2000 Ford Mustang V6-3.8L VIN 4
Vehicle > Technical Service Bulletins

A/T COOLER - FLUID LEAKS AT RADIATOR

00-9-1

LEAK - TRANSMISSION FLUID LEAKS AT RADIATOR - VEHICLES EQUIPPED WITH AUTOMATIC TRANSMISSION AND TRANSMISSION OIL COOLER IN RADIATOR END TANK

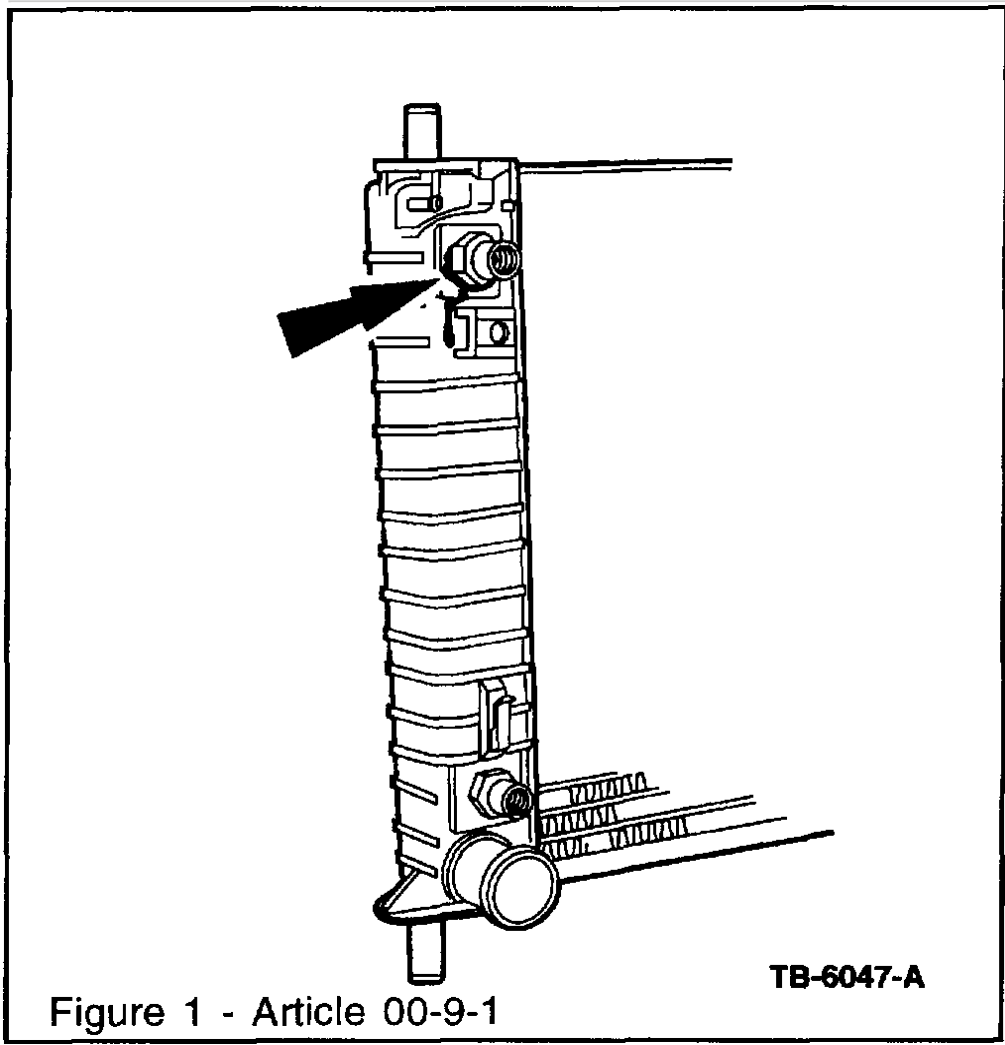
Transmission fluid may leak between the radiator transmission oil cooler and the transmission oil cooler fitting (NOT the cooler line into the fitting), which may result in a residue of transmission fluid on the radiator tank around the transmission oil cooler fitting. This may be caused by insufficient thread sealer on the transmission oil cooler fitting.

1. Verify that transmission fluid is leaking between the transmission oil cooler and the transmission oil cooler fitting (NOT the transmission cooler line fitting into the transmission oil cooler fitting). Refer to Figure 1.

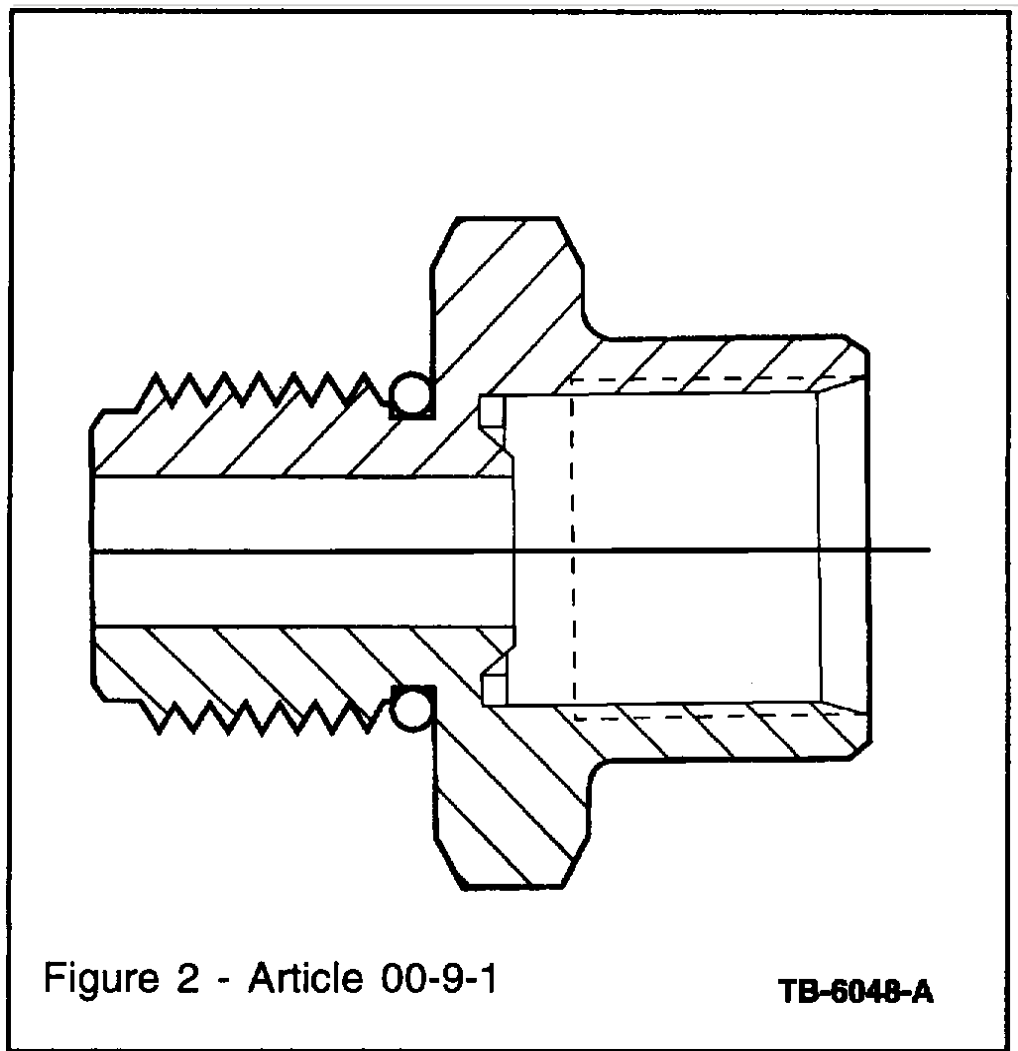
2. Remove the radiator from the vehicle following Workshop Manual procedure. Place the radiator on a flat surface so that the transmission oil cooler fittings are facing upward. Refer to Figure 2.

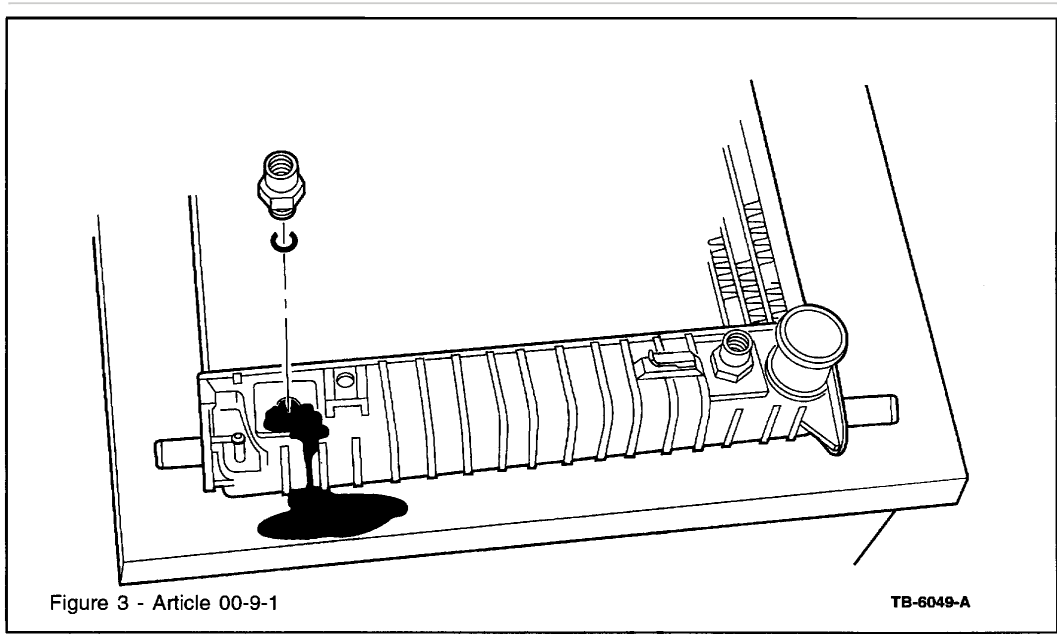
7. Install O-ring W705181-S on the transmission oil cooler fitting. Refer to Figures 2 and 3.

8. Making sure that the gasket between the transmission oil cooler and the inside of the radiator tank is still in place, reinstall the transmission oil cooler fitting. The fitting should be torqued to 38-45 N.m (28-33 lb-ft).
